ODSCC ARC Submittal for Watts Bar Nuclear Plant

**Tennessee Valley Authority
Watts Bar Nuclear Plant
NRC Meeting
7/17/01**

Answer to Outstanding RAIs

Figure 1: STP Model
Pre-accident Iodine Spike

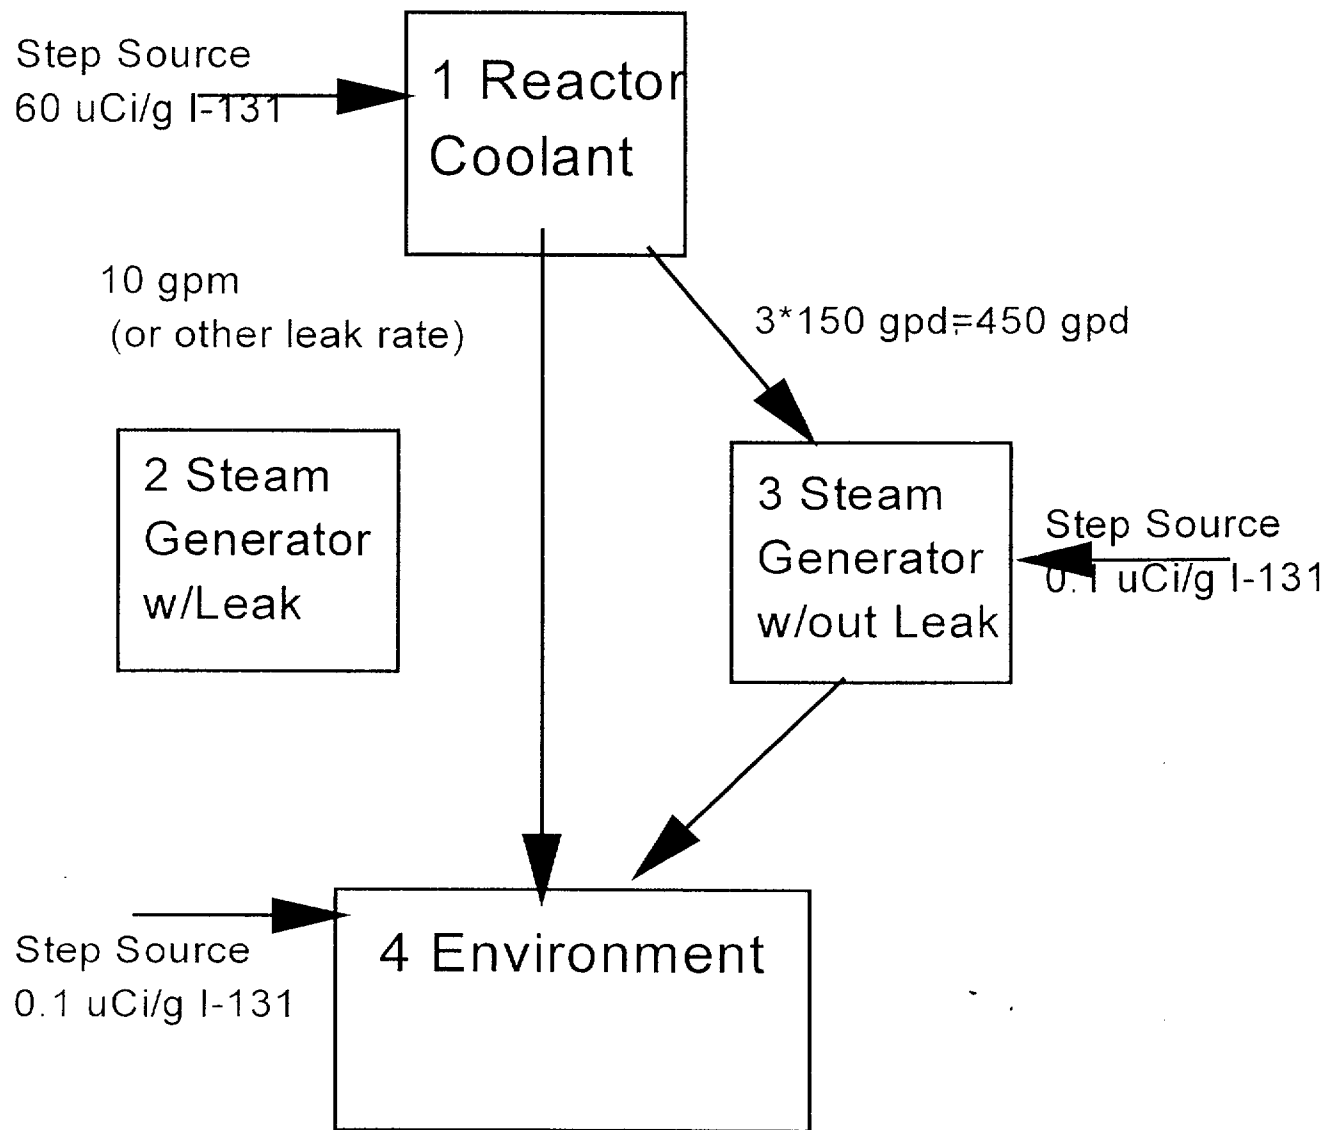
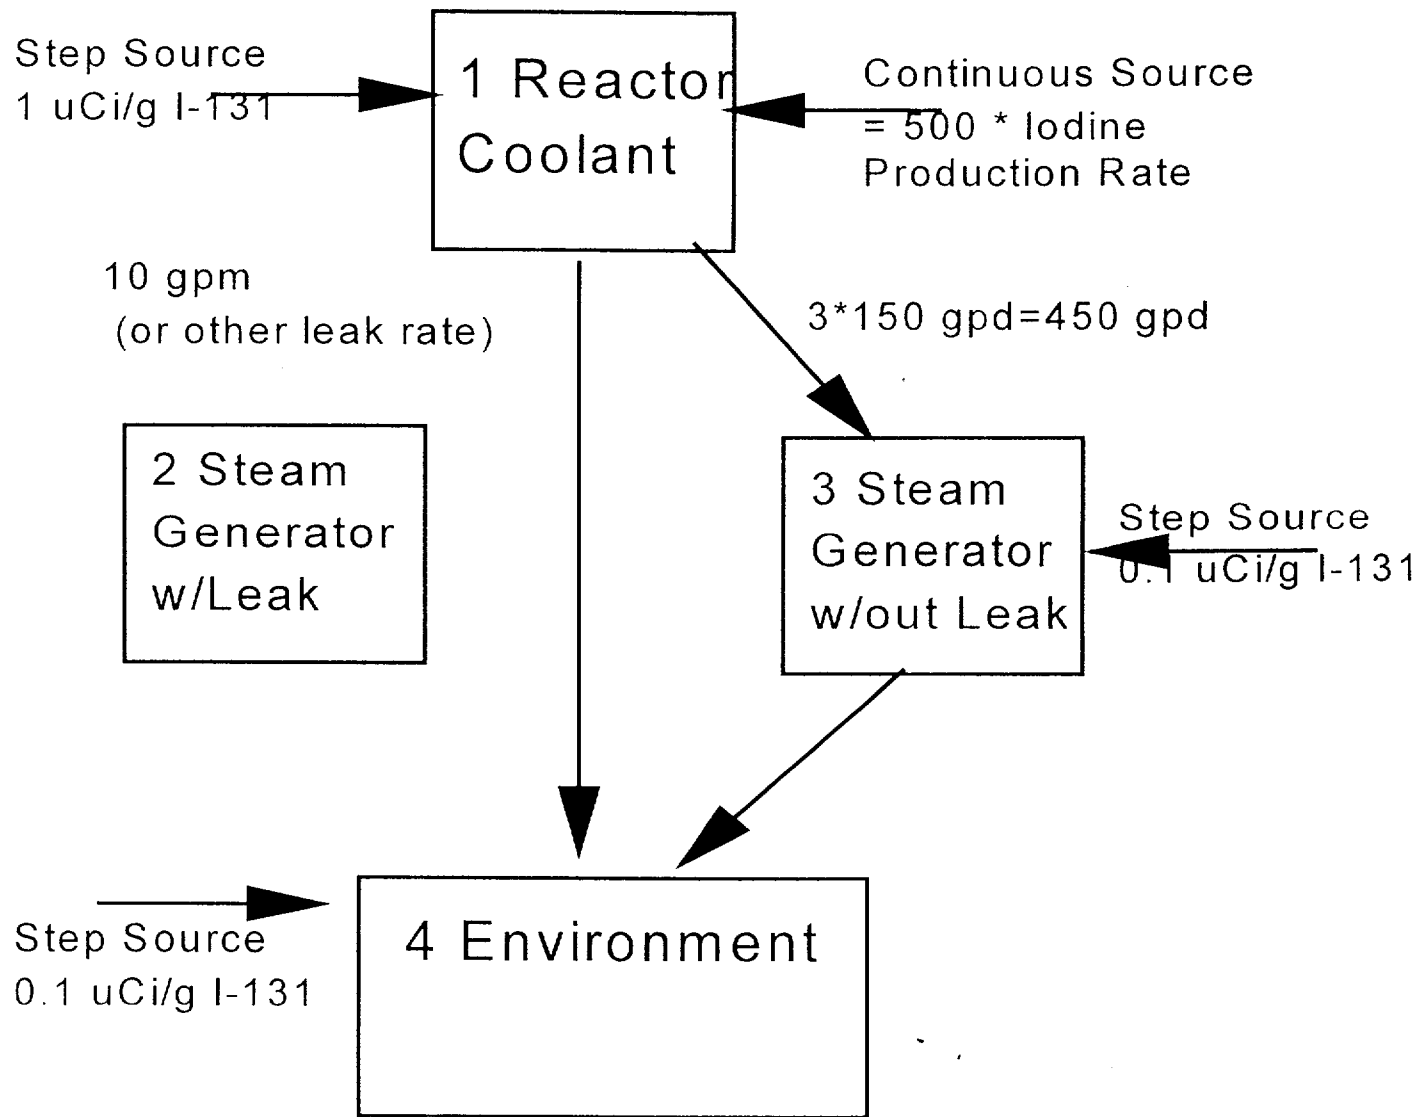
- **Flows of 150,000 lb and 2509 lb should be considered separately since the 150,000 lb is secondary side at 0.1 uCi/gm and the 2509 lb is primary side at a higher concentration.**
- **Response: Agree. The revised calculation model steps the 150,000 lb secondary side into the environment at time 0. The RCS primary side leakage is modeled separately as a flow from the RCS to the environment.**
